ALLEGHENY COUNTY SANITARY AUTHORITY

CONTRACT NO. 1759 G, E, H, P

ENVIRONMENTAL COMPLIANCE FACILITY

ADDENDUM NO. 4

1 OVERALL ROOF PLAN
 1/8" = 1'-0"

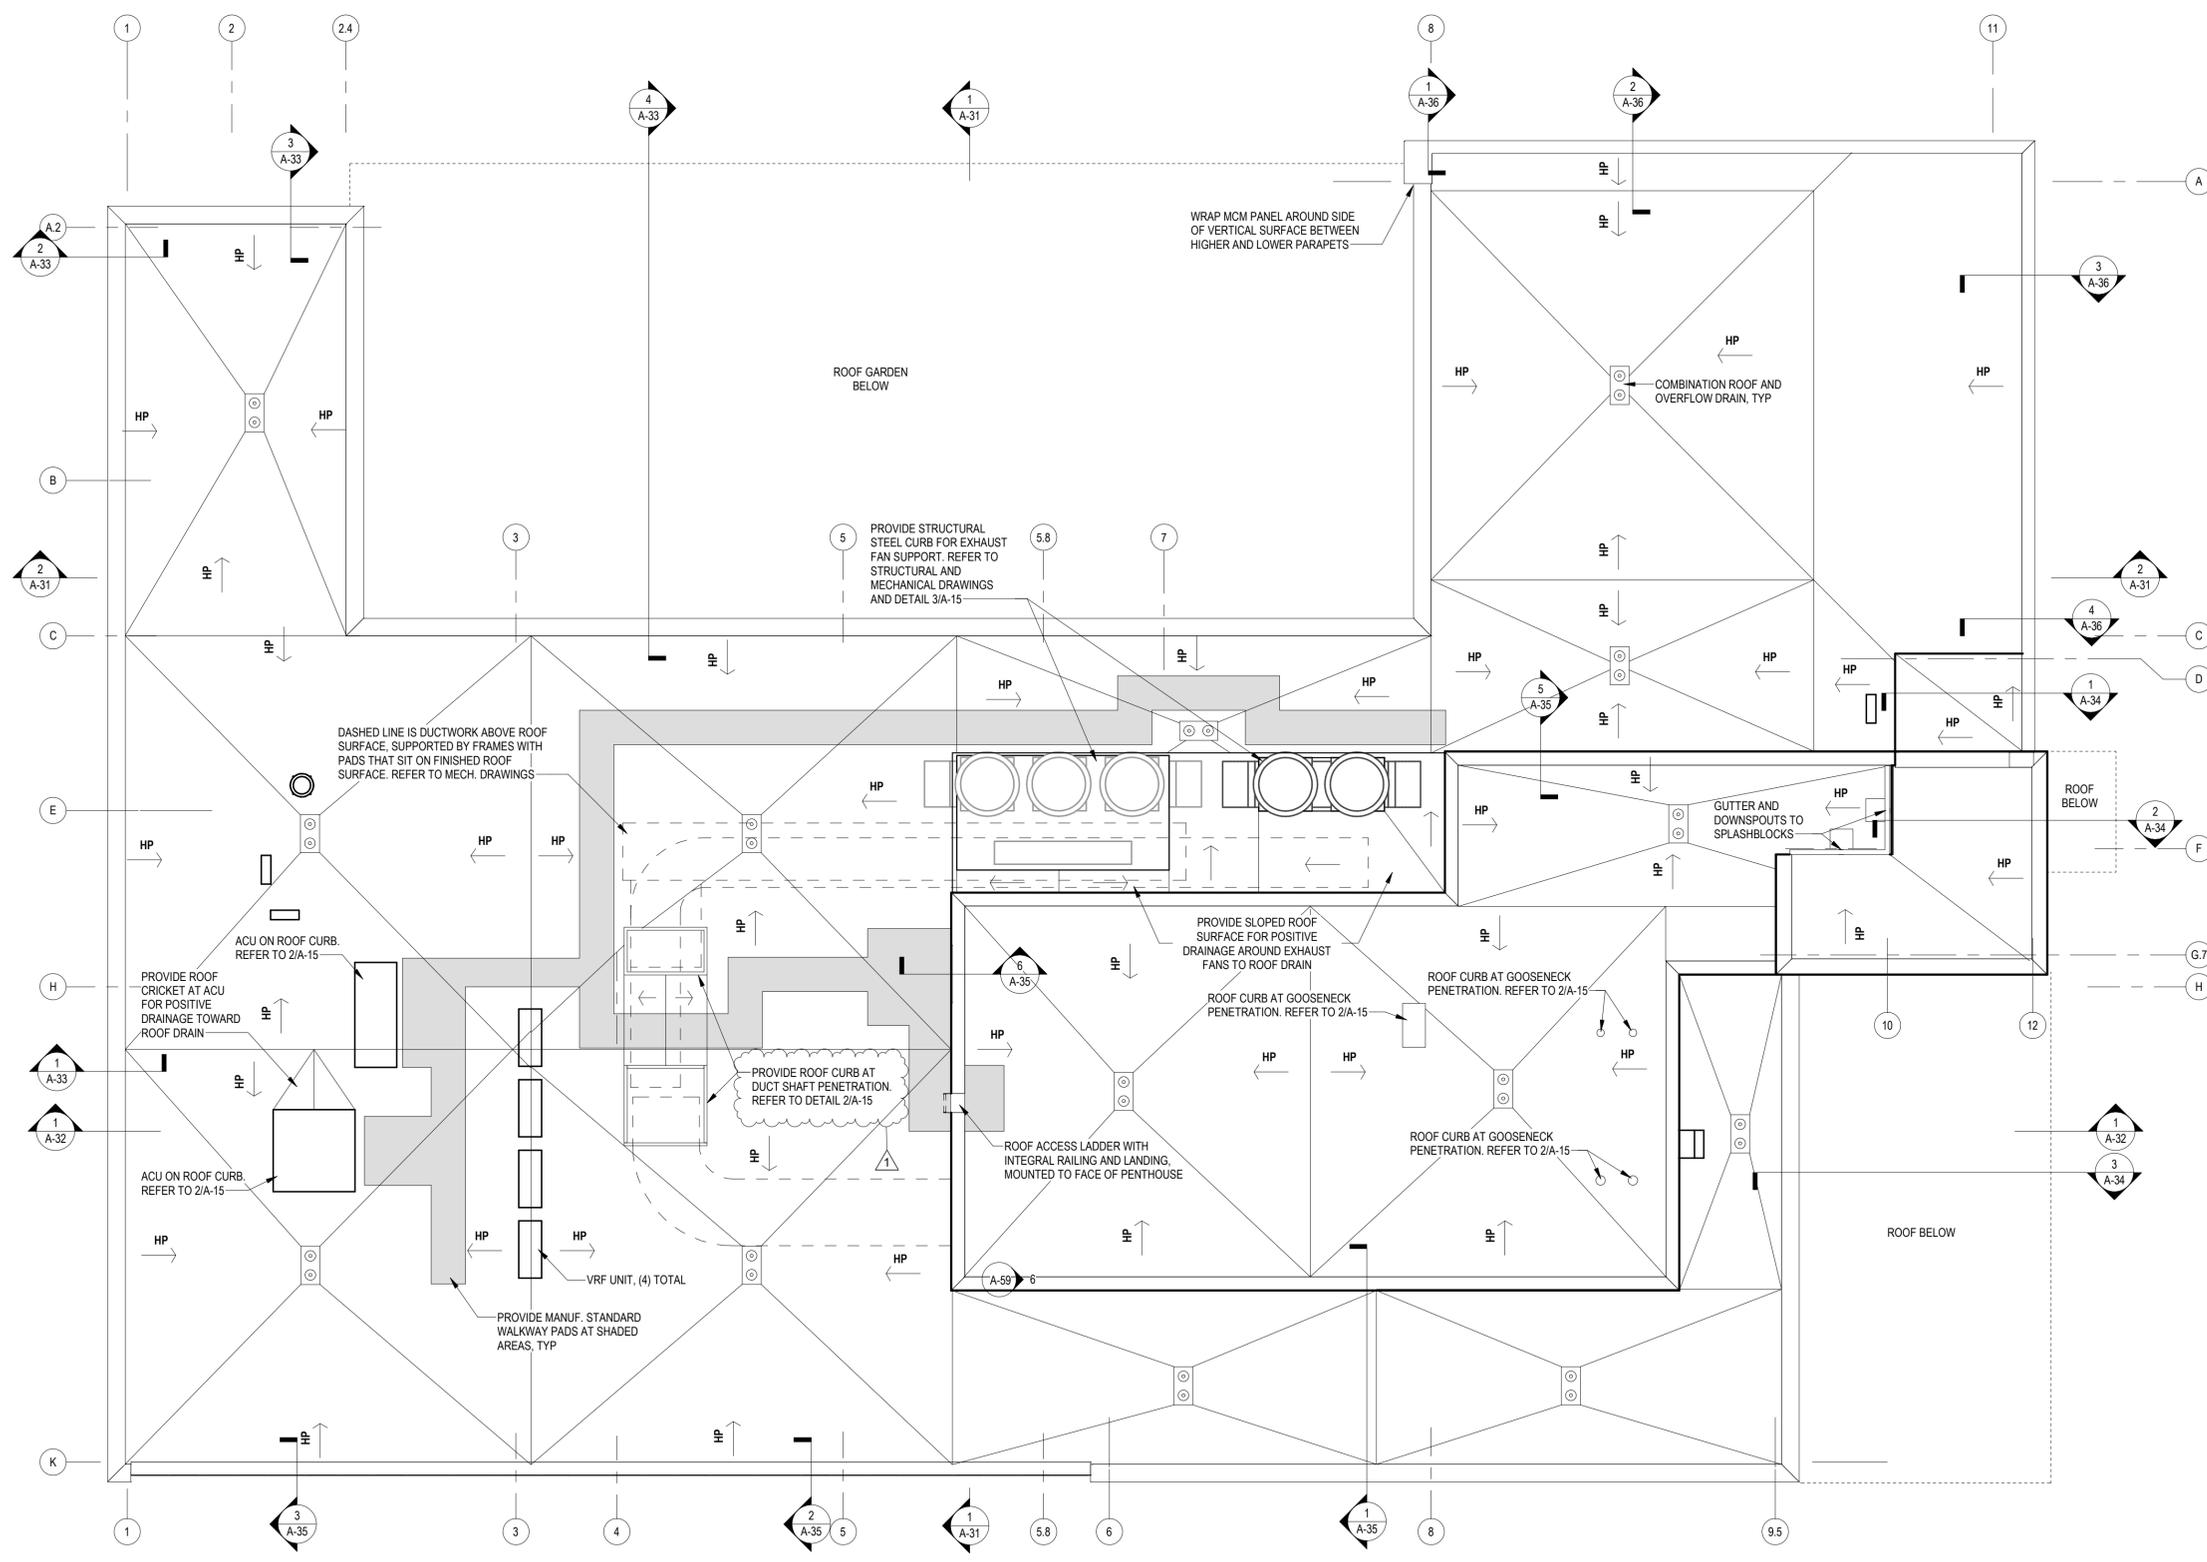
- a. Revised note to reference detail 2/A-15.
13. Drawing 220-A-40 – Enlarged Plans and Elevations
 - a. Added notes indicating sump pit and elevator pit access ladder locations.

Q65: Note on drawing 220-A-15 pointing to two duct shaft openings along column line 4 refers to detail 3/A-15. Since these are duct shaft penetrations, shouldn't the note refer to detail 2/A-15? This is also supported by the structural drawings as they do not show the channel frame at these openings.

A65: The text will be updated to reference detail 2 / A-15

220-A-42
ENLARGED PLANS & ELEVATIONS

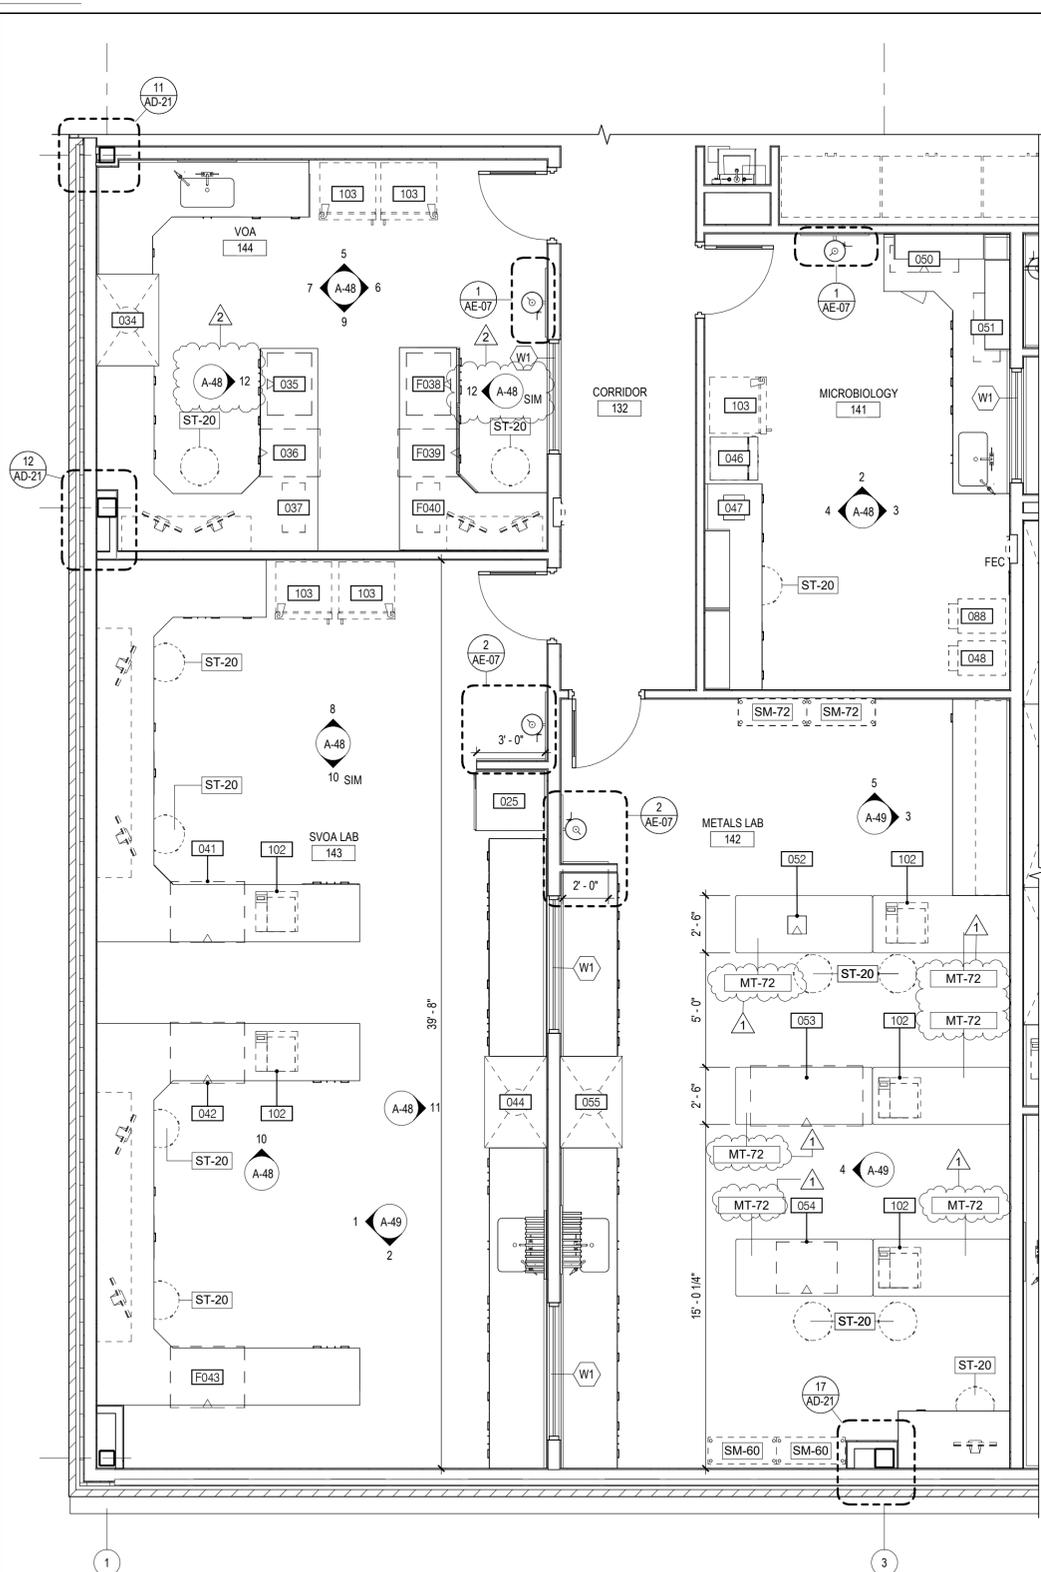
14. Drawing 220-A-42 – Enlarged Plans and Elevations
 - a. Added Fiber-Reinforced Panel (FRP-1) locations to the finish plans.
 - b. Added general note: *All lab casework with exposed cabinet faces to receive finished side and/or back panels.*

1 OVERALL FINISH PLAN - FIRST FLOOR
1/8" = 1'-0"

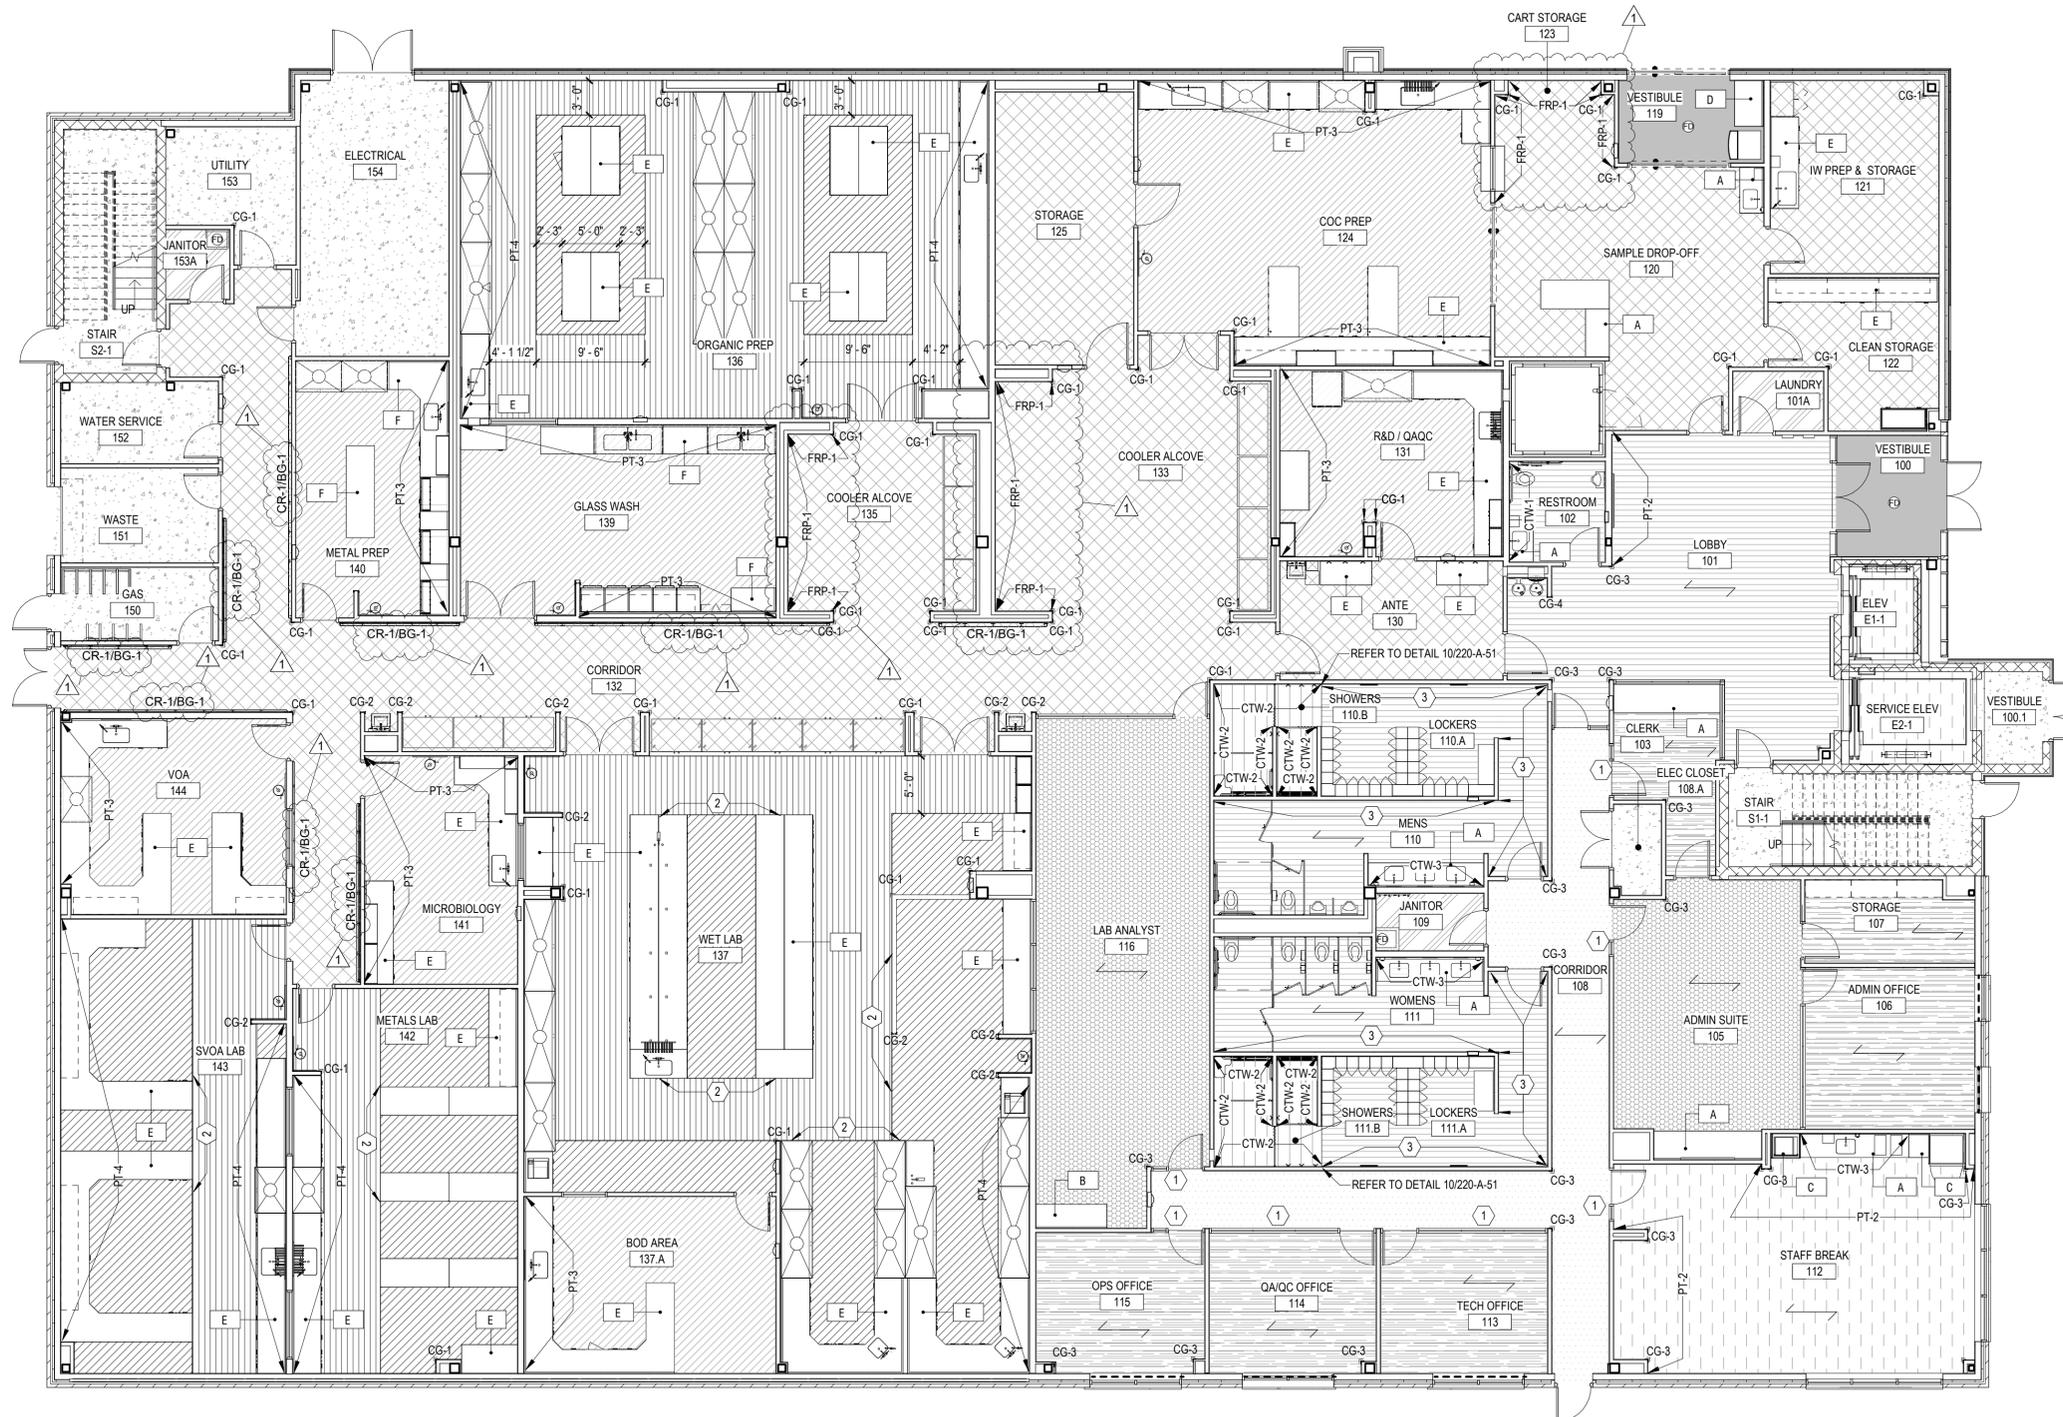
- a. Revised installation source of F026 Flask Scrubber to OFOI.
18. Drawing 220-AI-01 – Overall Finish Plan – First Floor
 - a. Added Fiber-Reinforced Panel (FRP-1) tag locations to the plan.

- b. Added Crash Rail (CR-1) and Bumper Guard (BG-1) tag locations to the plan.
19. Drawing 220-AI-05 – Finish Schedules and Details
 - a. Added Fiber-Reinforced Panel (FRP-1) tag locations to the schedules.

Q4: Finish Legend on drawing AI-06 indicates that are CR-1 Crash Rails and so does Detail 6/AD-05. CR-1 cannot be located on floor plans. Please confirm that there are crash rails and the locations.

Q5: Finish Legend on drawing AI-06 indicates that are BG-1 Bumper Guard and so does Detail 6/AD-05. BG-1 cannot be located on floor plans. Please confirm that there are bumper guards and the locations.

Q6: Finish Legend on drawing AI-06 indicates that are FRP-1 Fiber Reinforced Panel. FRP-1 cannot be located on floor plans. Please clarify locations.
